In Support of Test Fixtures Comments

IEEE 802.3ck Taskforce Meeting

- ❑ **This presentation is supplemental to comments submitted against 802.3ck D1.0, addressing comments related to mated test fixture for C2M/CR and KR/CR test boards**
 - Comment 172
 - Comment 173
 - Comment 177
 - Comment 185
 - Comment 186
 - Comment 187
 - Comment 188.

Update to KR Test Fixture IL and RL (Comment 172, 173)

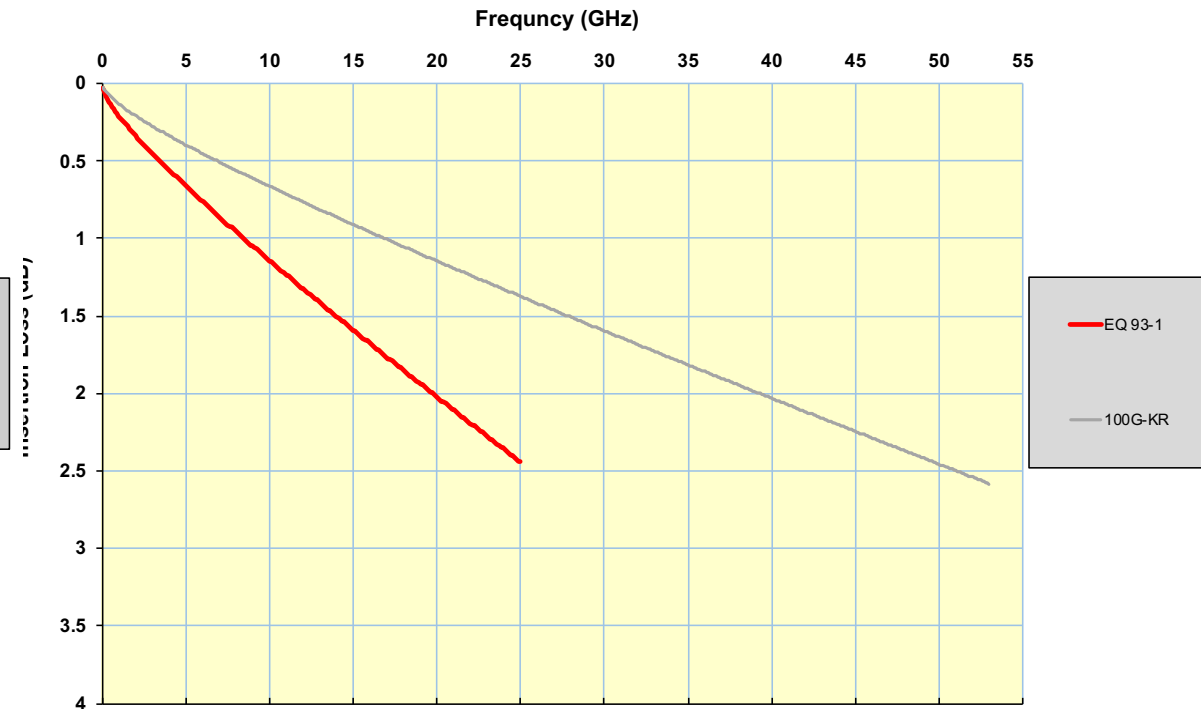
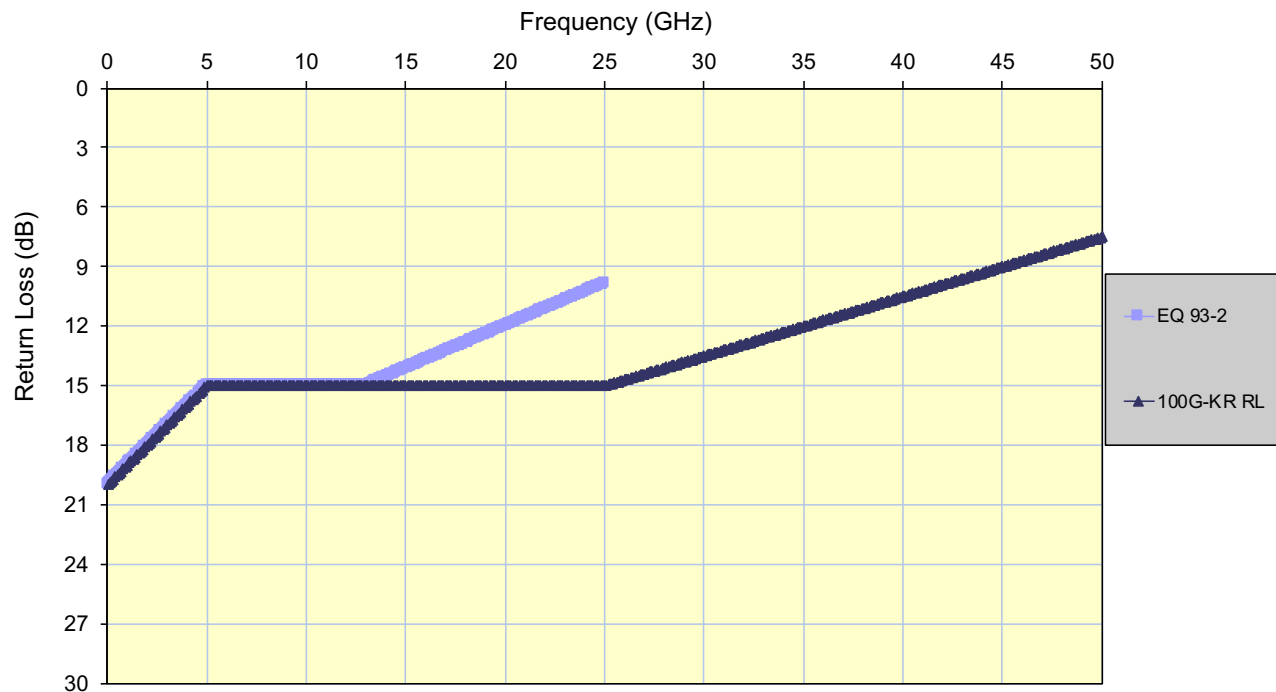
- RL scaled but IL max RL at 50 GHz reduced from 9.85 dB to 7.5 dB due to difficulty one would have meeting the RL at 50 GHz.

$$RL_d(f) \geq \begin{cases} 20 - f \text{ dB} & 0.05 \leq f \leq 5 \text{ GHz} \\ 15 \text{ dB} & 5 < f \leq 25 \text{ GHz} \\ 22.5 - 0.3f \text{ dB}, & 25 < f \leq 50 \text{ GHz} \end{cases}$$

$$Il_{ref}(f) = -0.0015 + 0.1\sqrt{f} + 0.035f \quad 0.05 \leq f \leq 50 \text{ GHz}$$

Mated Board IL (Comment 185)

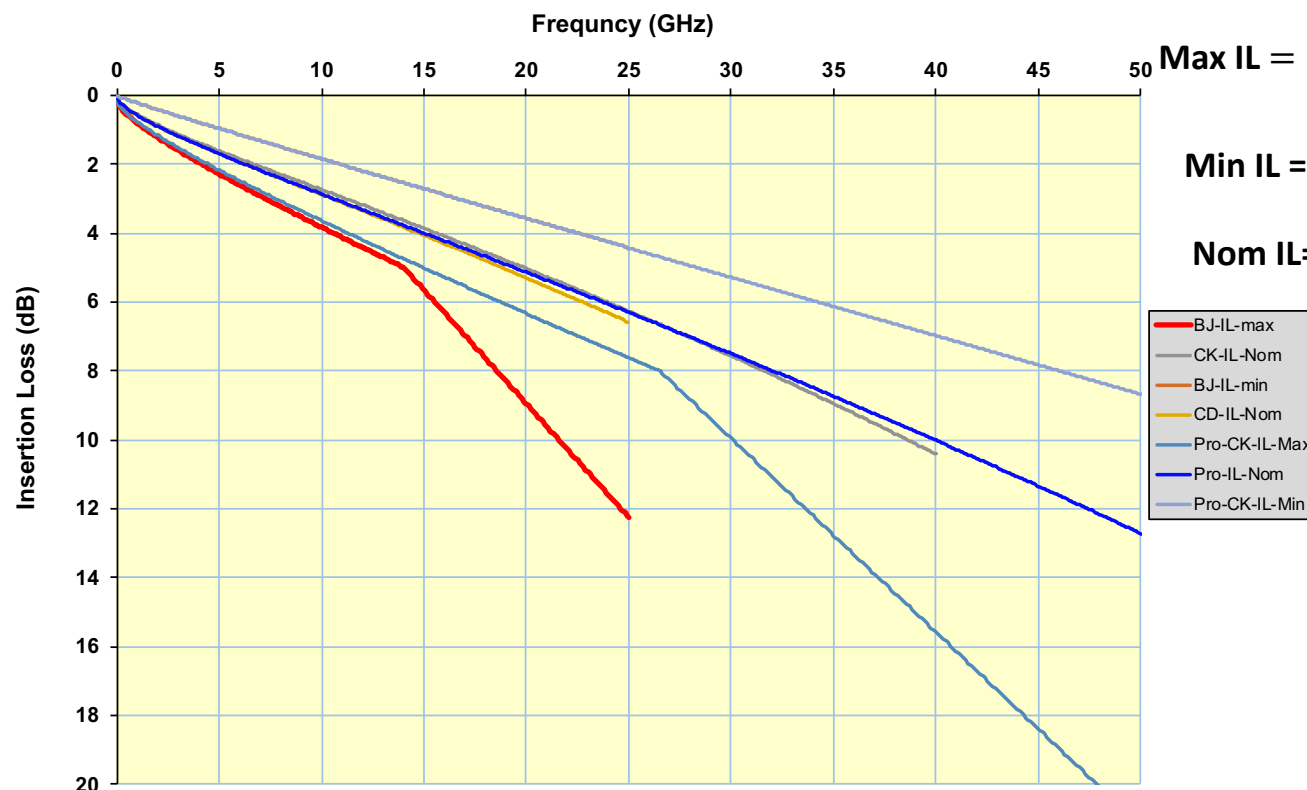
□ Maintaining the current 6.6 dB loss at 26.55 GHz but adjusting f^2 factor slightly to remove curve past 30 GHz

- Also providing min and max loss to replace TBDs
- FOM ILD (max) ≤ 0.1 dB over range of 0.01-40 GHz.

$$\text{Max IL} = \begin{cases} (0.12 + 0.475 \times \sqrt{f} + 0.221 \times f) \times 0.9503 \text{ dB} & 0.01 \leq f \leq 26.55 \text{ GHz} \\ 6.9505 + 0.562 \times f & 26.55 < f \leq 50 \text{ GHz} \end{cases}$$

$$\text{Min IL} = 0.0656 \times \sqrt{f} + 0.164 \times f$$

$$\text{Nom IL} = 0.9503 \times (0.471 \sqrt{f} + 0.141f + 0.0012 \times f^2) \quad 0.05 \leq f \leq 50 \text{ GHz}$$

Mated Board SDD11/22 (Comment 188)

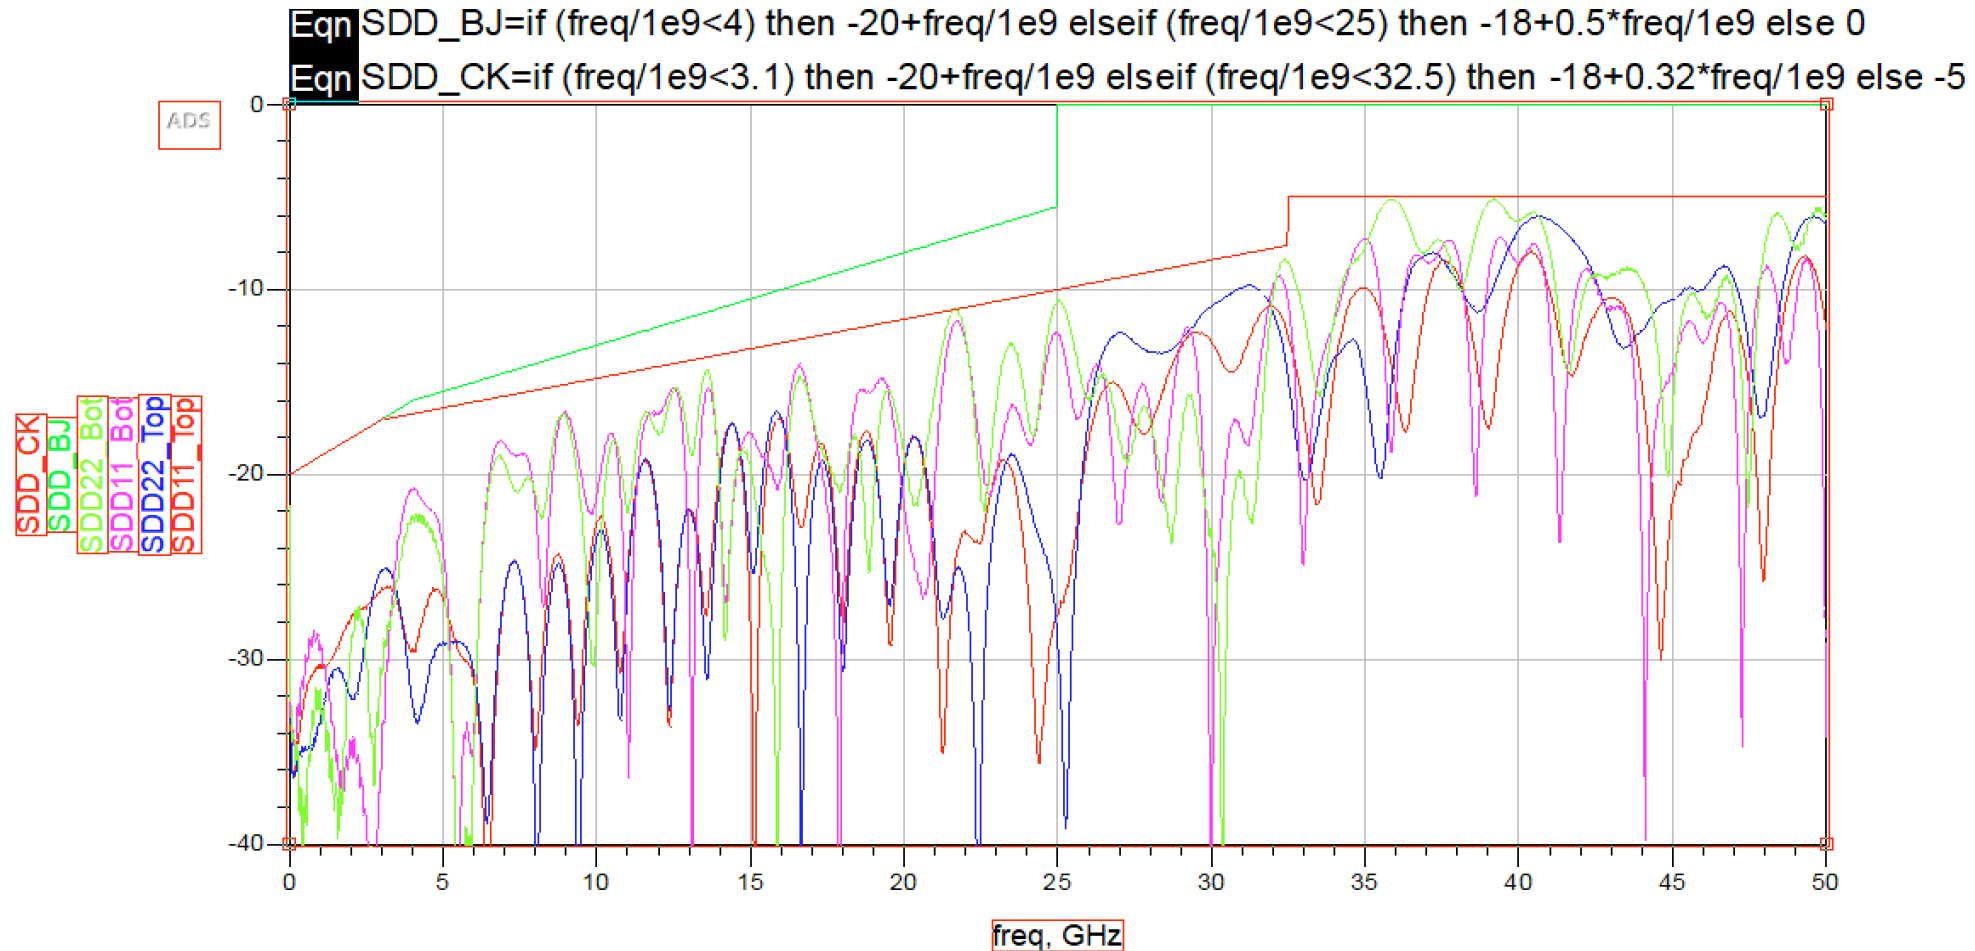
□ Proposed SDD extend the BJ SDD11/SDD22 masks

- Graph below shows S-parameters for RL invert the sign.

Mated Board SCC11/22

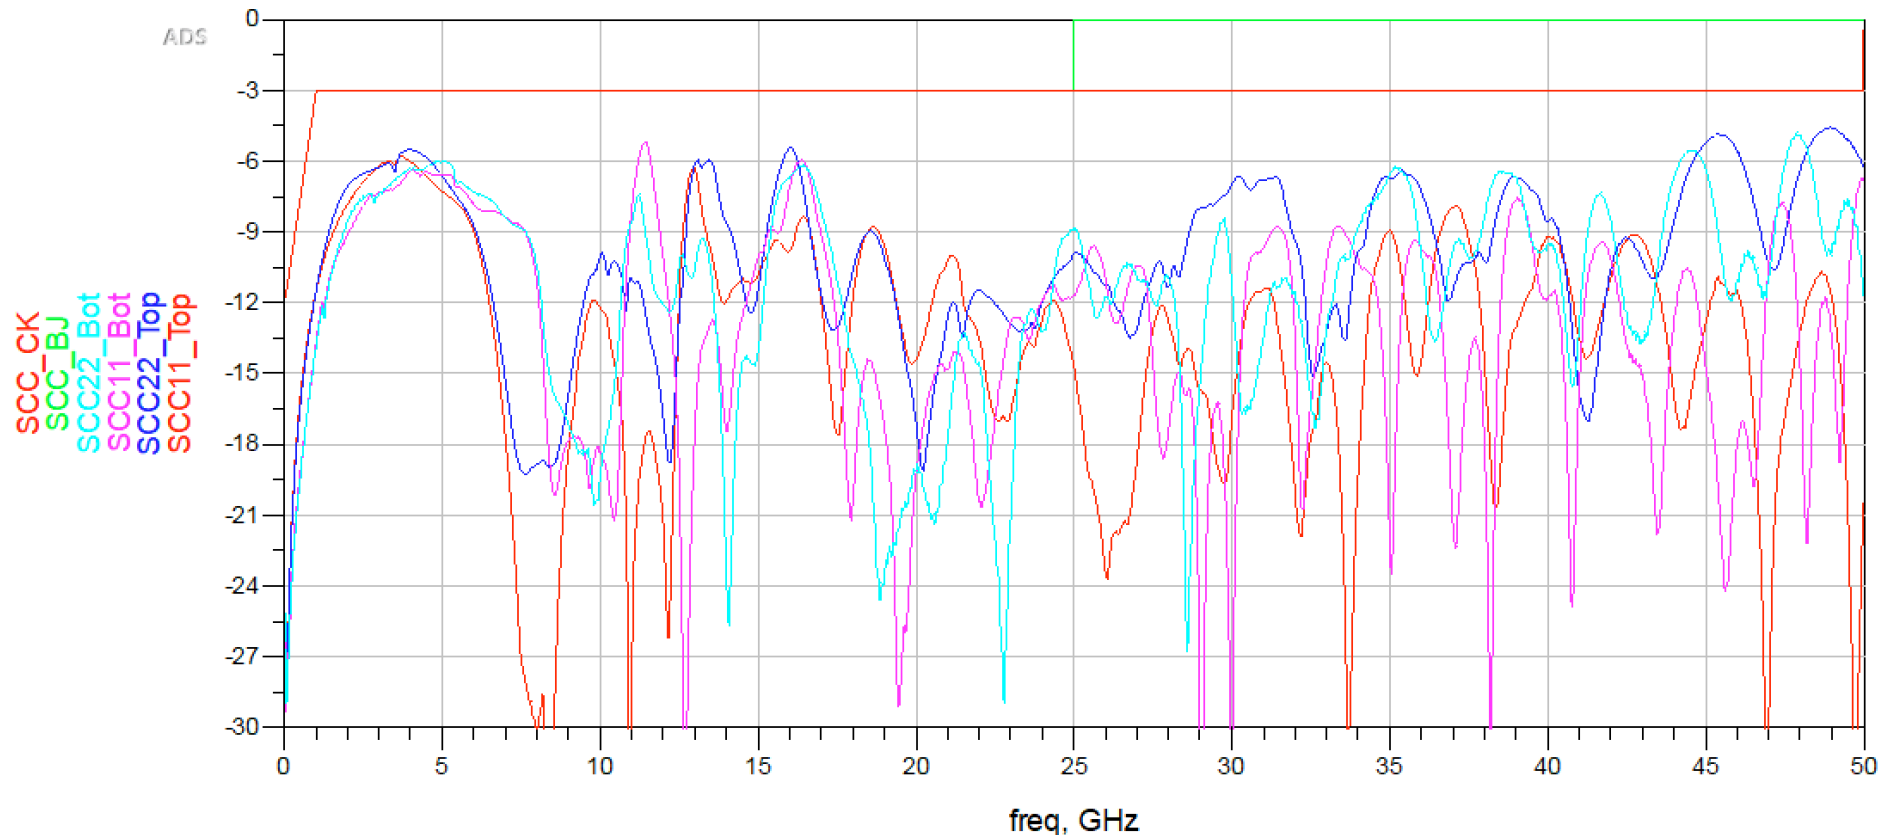
□ Proposed common mode RL extend the BJ SCC11/SCC22 masks

- Graph below shows S-parameters for RL invert the sign.

Eqn SCC_BJ=if (freq/1e9<1) then -12+9*freq/1e9 elseif (freq/1e9<25) then -3 else 0
Eqn SCC_CK=if (freq/1e9<1) then -12+9*freq/1e9 elseif (freq/1e9<50) then -3 else 0

Mated Board SDC11/22 (Comment 186)

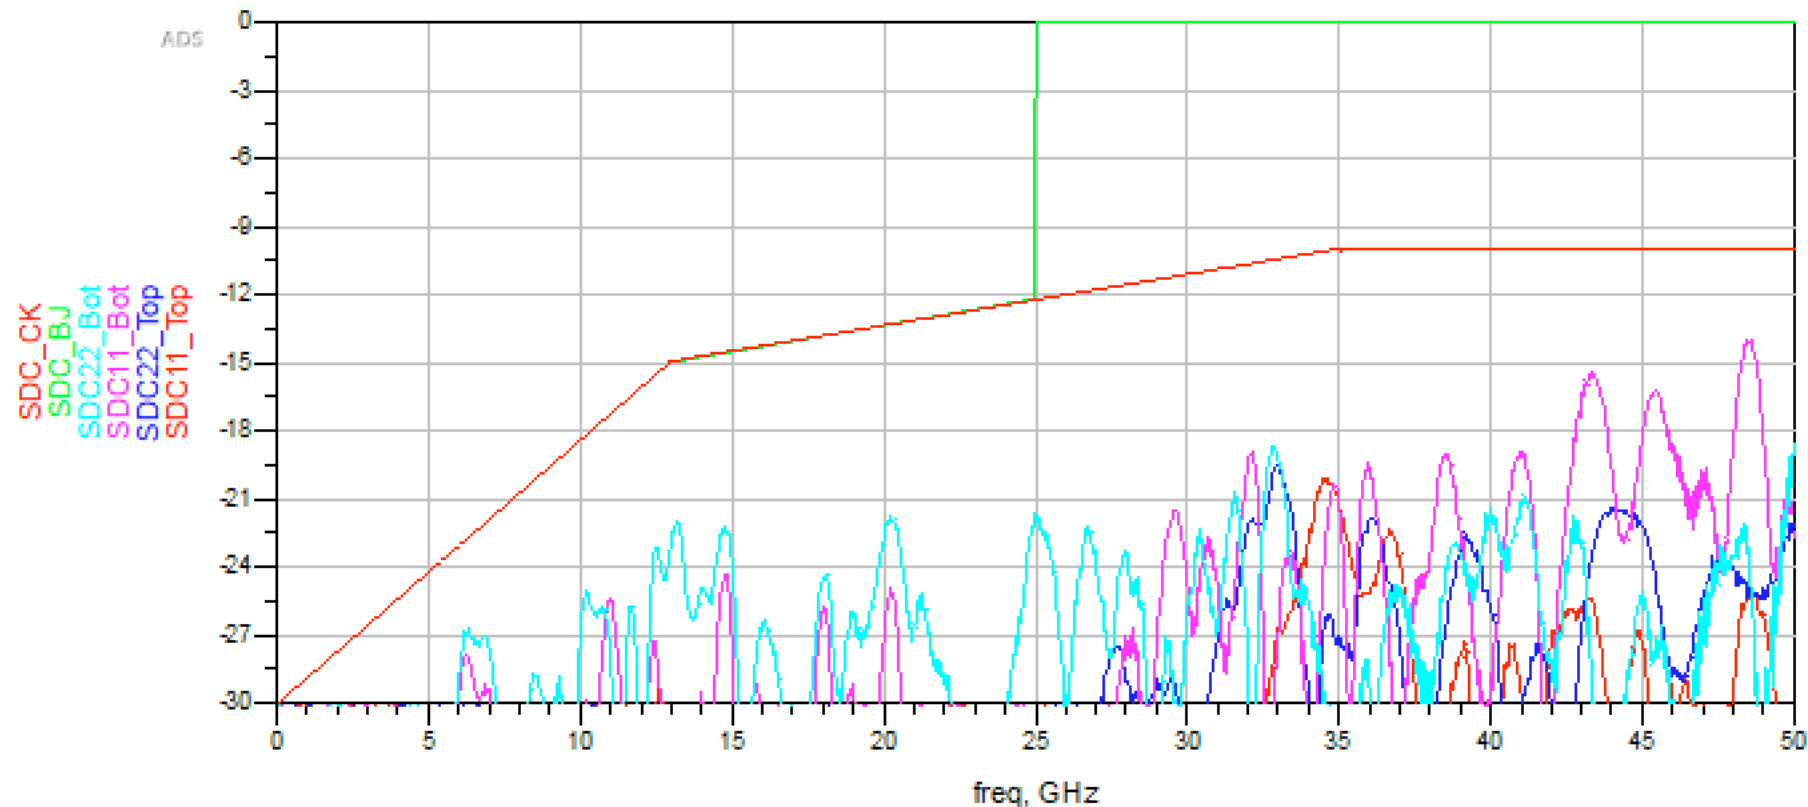
□ Proposed common mode to differential extend the BJ SDC11/22 masks

- Graph below shows S-parameters for RL invert the sign.

Eqn SDC_BJ=if (freq/1e9<12.89) then -30+30*freq/1e9/25.78 elseif (freq/1e9<25) then -18+6*freq/25.78/1e9 else 0

Eqn SDC_CK=if (freq/1e9<12.89) then -30+30*freq/1e9/25.78 elseif (freq/1e9<35) then -17.85+0.225*freq/1e9 else -10
